ZONING BOARD OF APPEALS STAFF REPORT

REGARDING: 48700 Grand River Ave, Parcels # 50-22-17-126-009 (PZ19-0013)

PLAN REVIEW CENTER REPORT

Interior Environments Parking Expansion
JSP 18-51

SITE PLAN

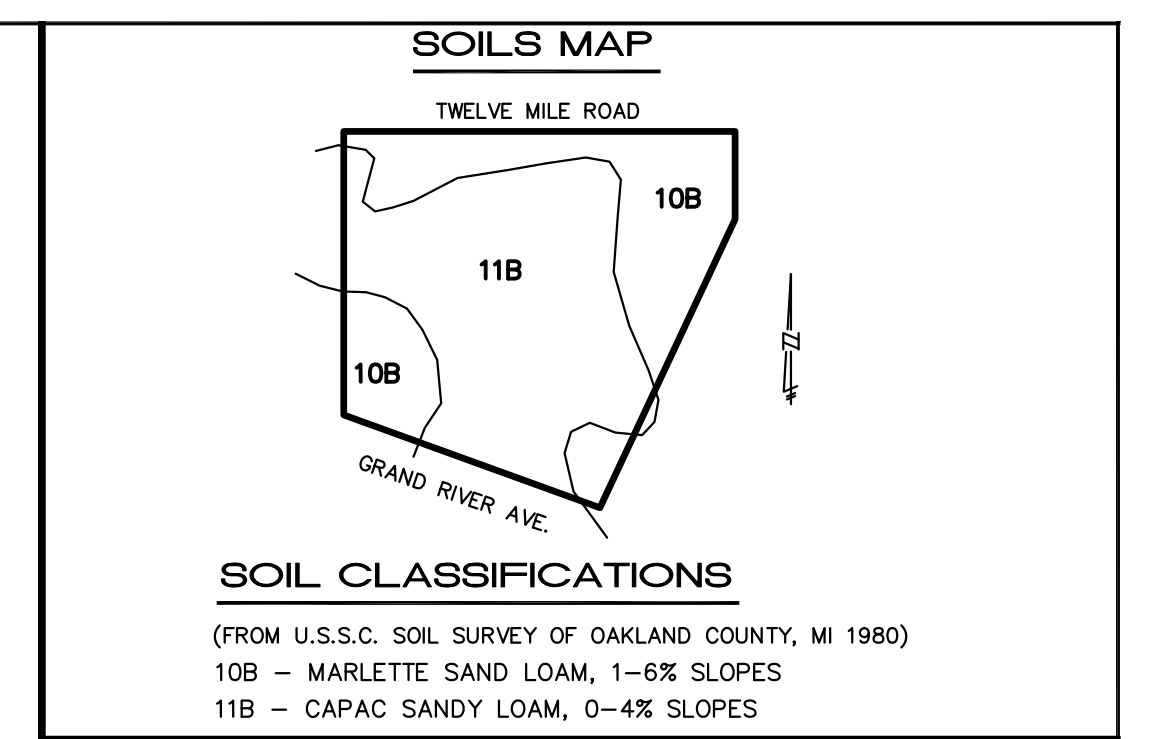
1. Parking Setbacks (Sec 3.1.23.D): The expansion to the parking lot would encroach 15 feet into the right-of-way (ROW) for Twelve Mile Road on the north side of the property, resulting in zero setback from the property line, and one parking space in the ROW. The applicant has provided an email from the Road Commission of Oakland County (RCOC) indicating the 15-foot encroachment into the ROW is acceptable. Parking is also proposed within the required parking setback on the south side adjacent to Grand River Avenue. **The required parking setback of both frontages is 20 feet, so the applicant must request variances from the Zoning Board of Appeals. Staff recommends the applicant remove the one parking space that falls within the right-of-way.**

2. End Islands (Sec. 5.3.12): Parking islands abutting traffic circulation aisles are generally required to be 3 feet shorter than the adjacent parking space. The applicant has indicated one end island on the western side of the south entrance needs to be 18 feet long to accommodate an existing light pole. **The applicant should request a variance from the Zoning Board of Appeals for this deviation.**

(1) NOW VARIANCE REQUIRED FOR LESS THAN 20' PARKING SETBACK
 RCOC APPROVAL REQUIRED FOR PAVING IN 12 MILE ROAD R.O.W.

(2) NOW VARIANCE REQUIRED FOR LESS THAN 20' PARKING SETBACK

(3) NOW VARIANCE REQUIRED FOR MORE THAN 16' FOR END ISLAND DEPTH

- PROPOSED VARIANCE**
- ZONING VARIANCE FOR PARKING SETBACK ALONG 12 MILE ROAD:
 REQUIRED= 20'
 PROPOSED= 0'
 - ZONING VARIANCE FOR PARKING SETBACK ALONG GRAND RIVER AVE.:
 REQUIRED= 20'
 PROPOSED= 14.5'
 - ZONING VARIANCE FOR END ISLAND DEPTH AS NOTED ON THE PLAN:
 REQUIRED= 16'
 PROPOSED= 17.5'
